Meeting note

Project name	East Midlands Gateway Phase 2 and East Midlands Gateway Rail Freight Interchange Material Change
Case reference	BC0410001 and TR0510002
Status	Final
Author	Planning Inspectorate
Date of meeting	30 September 2025
Meeting with	SEGRO Properties Ltd and SEGRO (EMG) Ltd
Venue	Microsoft Teams
Circulation	All attendees

East Midlands Gateway 2 DCO application

Section 51 advice for applicant relating to documentation as to submission dated August 2025

Photomontages diagram

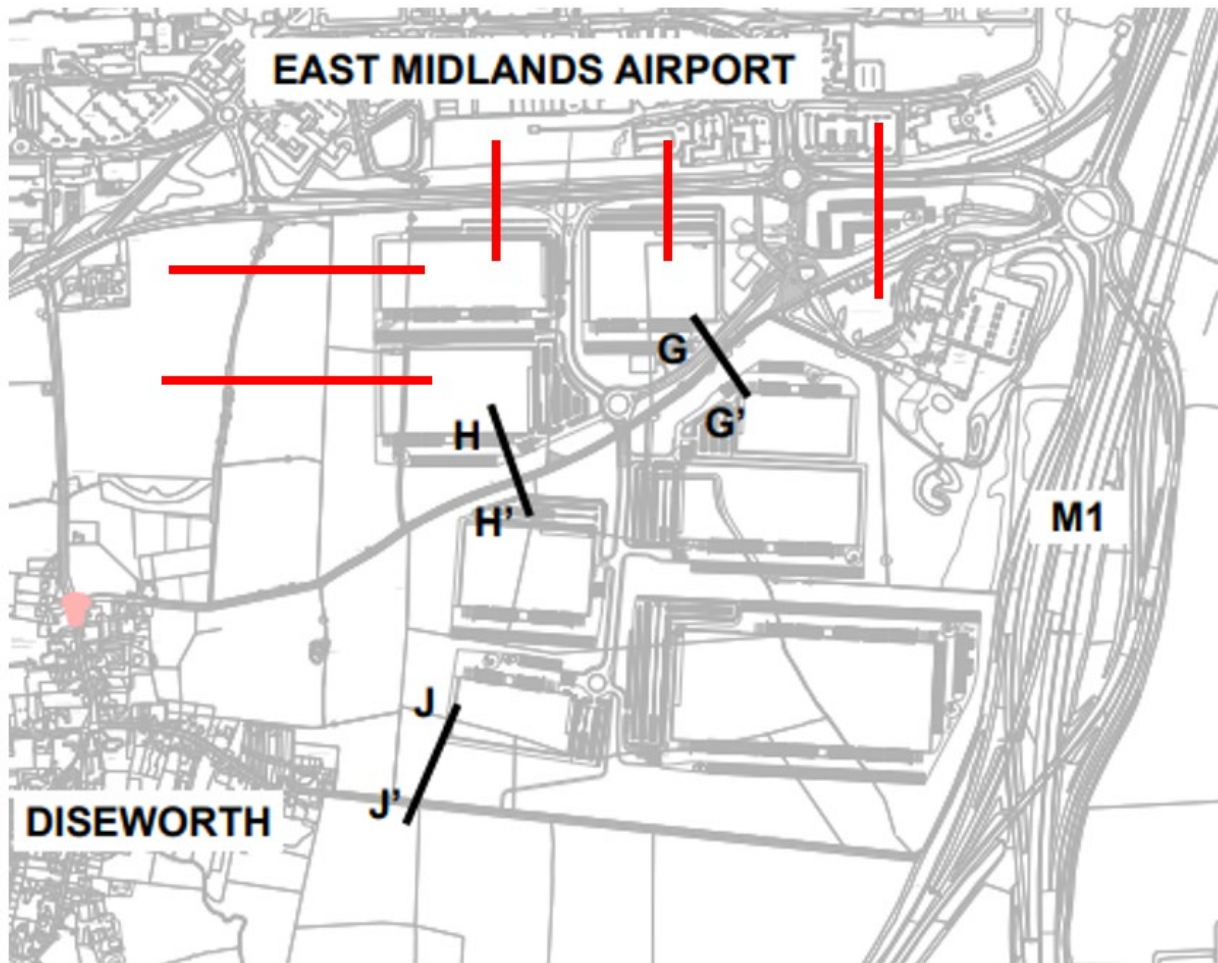
The Inspectorate acknowledges the documents provided in Appendix 6.10D and draws attention to the annotated drawing at the end of this document, which was provided after the meeting. Whilst two of the additional proposed sections depicted in the annotated drawing (shown in red) are in a similar location to the sections provided in Appendix 6.10D, the location of proposed additional sections extends further at either end of the proposed site. The Inspectorate stated that all sections should be at the same scale and for cross sections D and E to be produced at 1:500. The Inspectorate considers the night-time photomontages from both distant views, particularly high ground to the south, and closer views from Diseworth would be particularly useful. This should ensure assessment of occasions when there is significant water vapour in the atmosphere, for example, fog and mist.

Additional sections proposed, as highlighted in red.

35.	Lack of site sections and night-time photomontages	<p>(i) Provide wire diagrams of the buildings and other structures on site sections.</p> <p>(ii) Provide appropriate night-time photomontages.</p>
<u>Disclaimers</u>

The applicant stated that night-time photomontages would be provided and the Inspectorate agreed that these could be made available after acceptance and before examination
